**UNITED STATES ENVIRONMENTAL PROTECTION AGENCY  
REGION V**

**DATE:** February 22, 2007

**SUBJECT:** Monitoring Well Recommendations  
Chemical Recovery System Site

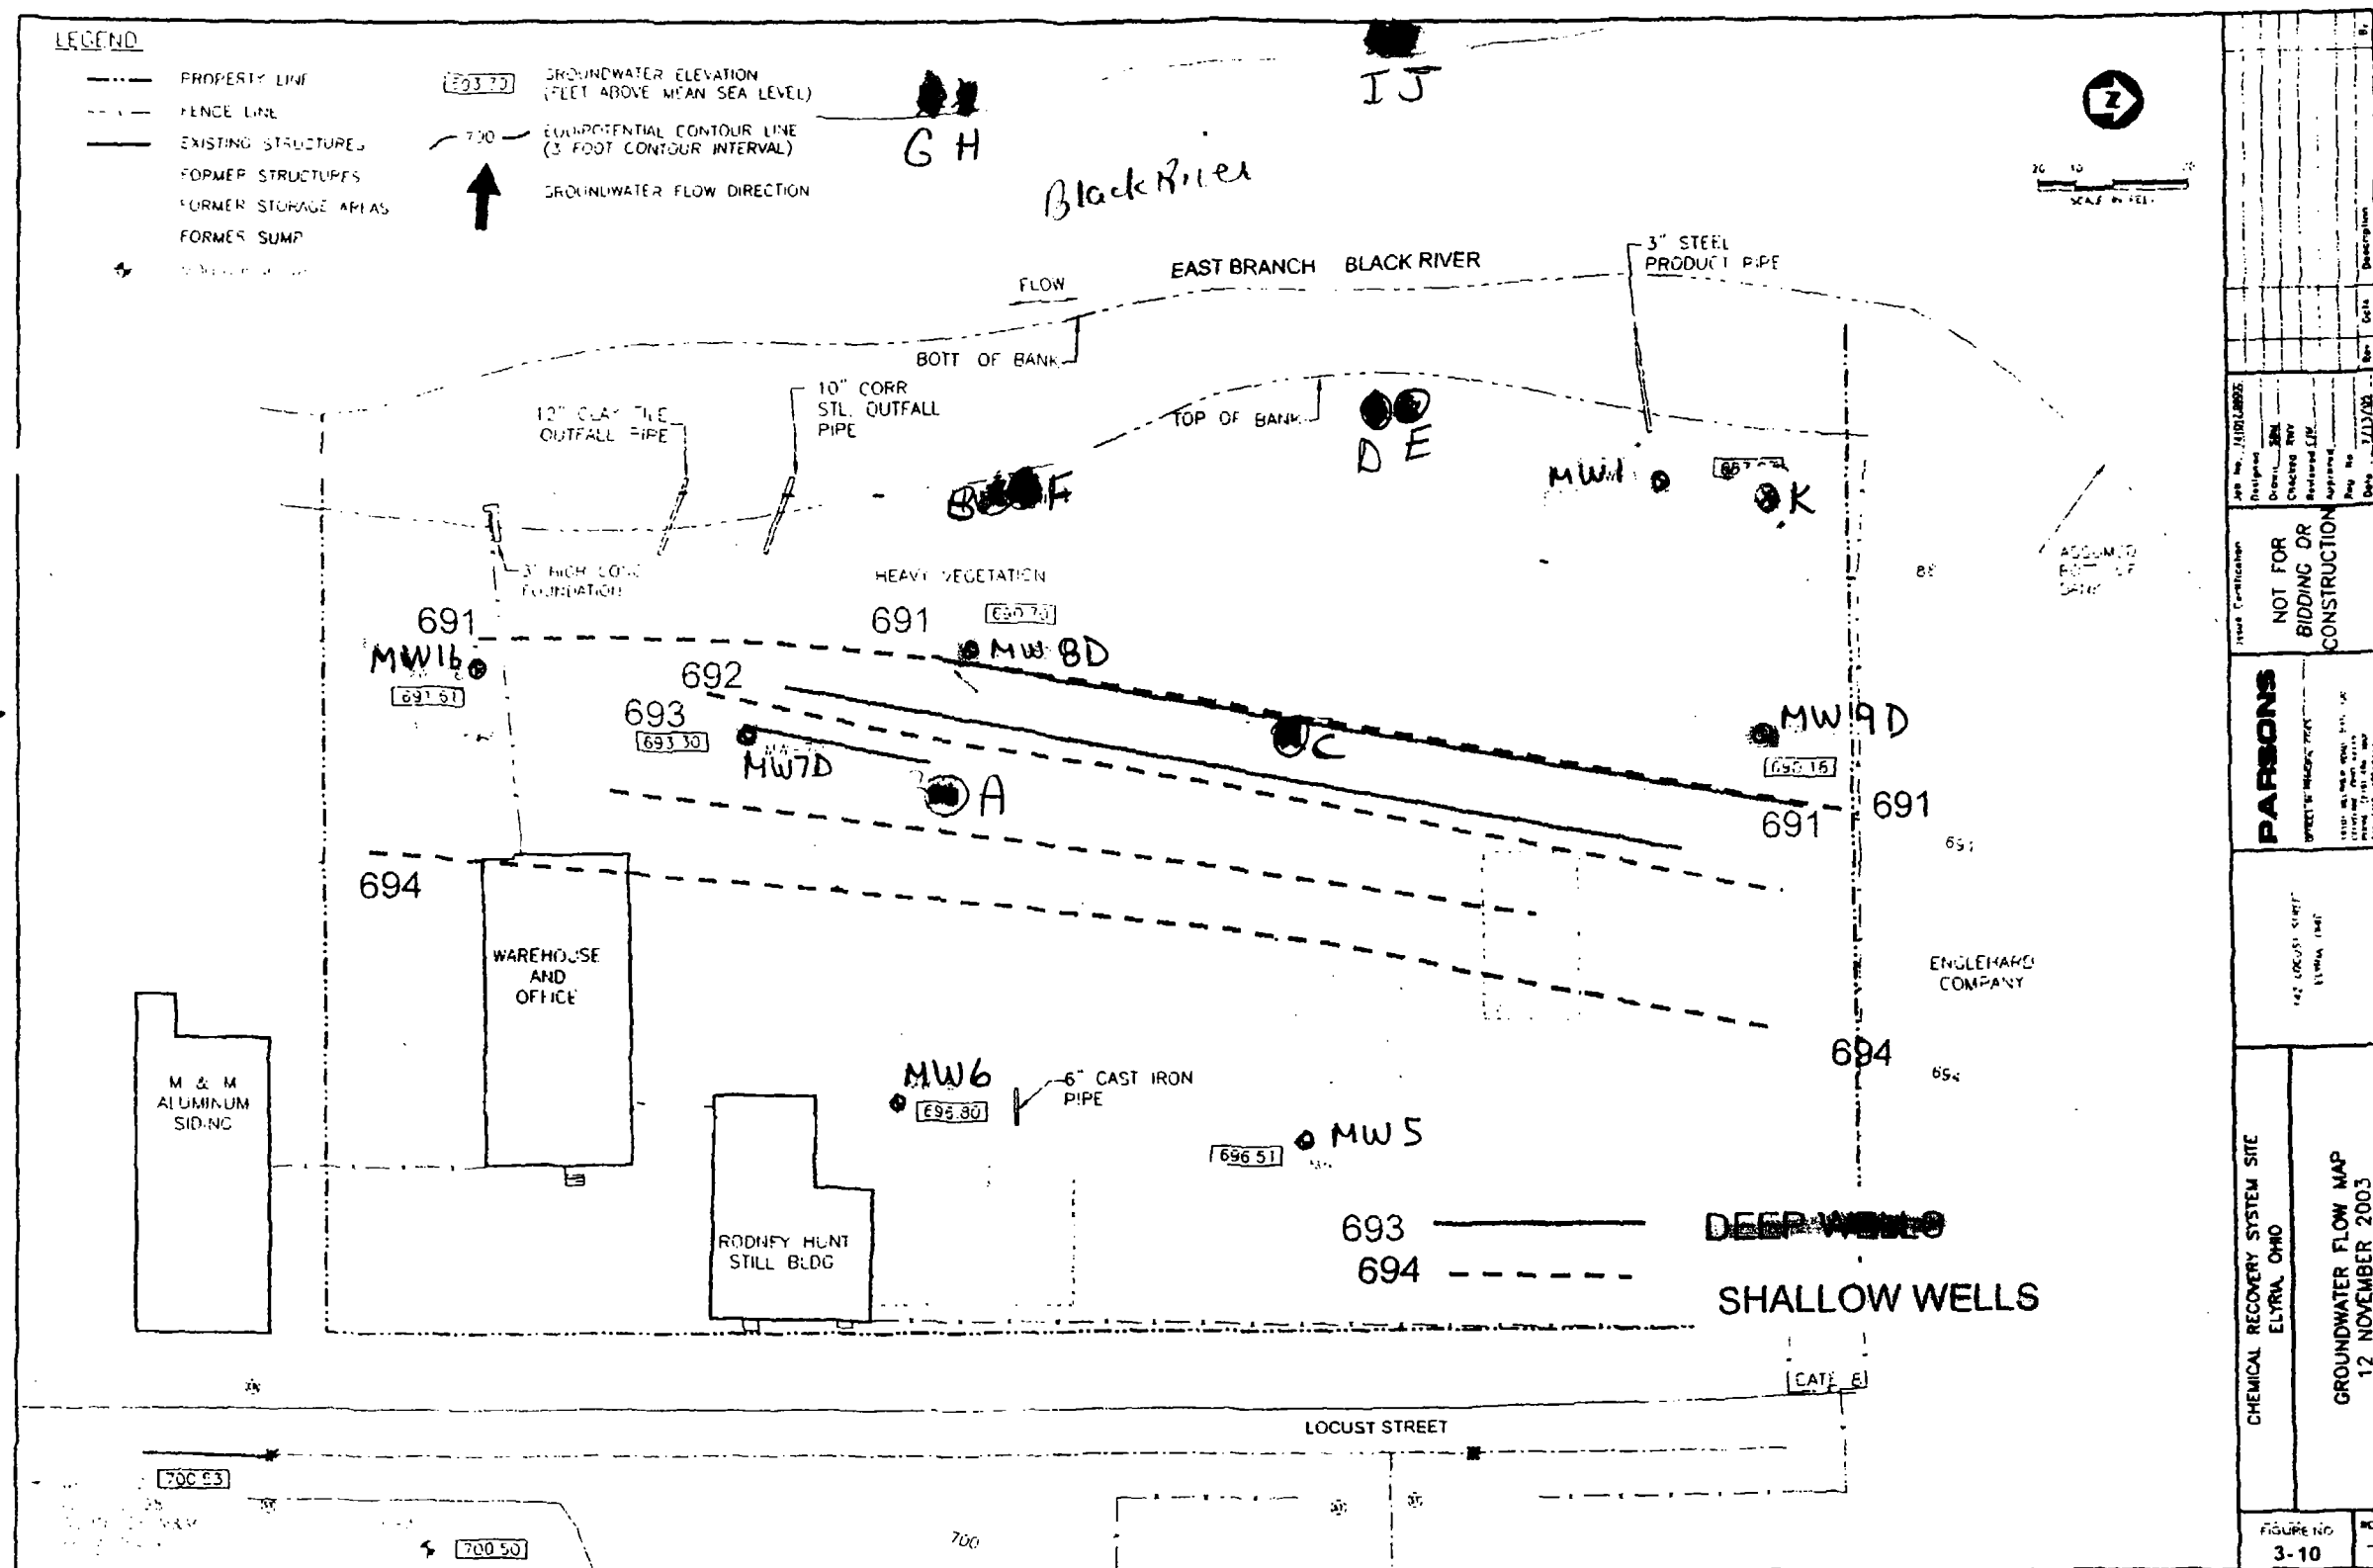
1. Vertically profile adjacent to MW-6 to confirm screen depth; sample MW-6 concurrently. If the vertical profiling at MW-6 reveals substantially higher levels of contamination at other depth(s), then replacing/augmenting MW-6 with a well screened at the depth of maximum contamination would be needed

2. Install 2 new shallow wells downgradient of MW-6; new well A south of the location of GP-32, the other well B near the edge of the top of the river bank. Vertically profile both locations to determine screen depth. These should be located along the core of the plume.

3. Install a shallow well (C) in the vicinity of the location of GP-36; (this will be slightly south of downgradient of MW-5). Vertically profile to determine screen depth. High levels were found at GP-16. It is unclear how far north the contamination extends (MW-5 is probably upgradient of this contamination). Hopefully this new well will serve as a lateral well and not find significant contamination.

4. Install deep (D) and shallow (E) wells downgradient of C near the edge of the top of the river bank.

5. Install deep well (F) adjacent to new well B. There is some contamination in MW-8D. The contamination is deep enough and limited vertical flow information suggests that if the contamination reaches the river, it would underflow.

6. Install deep (G) and shallow (H) well west of new wells B & F on the west side of Black River. Vertical profiling may be optional; screen placement could probably be reasonably decided based on the profiling on the east side of the river.

7. Install deep (I) and shallow (J) well west of new wells D & E on the west side of Black River. Vertical profiling may be optional.
8. Install shallow well (K) at or slightly west of GP-6. Vertically profile to determine screen depth. Compared to levels of contamination found at MW-6 and GP-16, contamination at the northern edge of the site is minor. But MW-1 and GP-6 have levels above criteria and screen depth of MW-1 is uncertain.

The most important wells are A, B, C, F. If there are not high levels found at C, then D and E are less important. If levels are low at B & F then G & H are less important. If levels are low at D & E, then I & J are less important. The deep shale wells G and I on the west side of the river are more important than the shallow wells H and J. The depth of the river valley makes underflow from the horizon screened by MW-6 unlikely; however levels of contamination at MW-6 are so high less than 200 feet from the river, that some monitoring at this horizon on the west side of the river seems justified. .
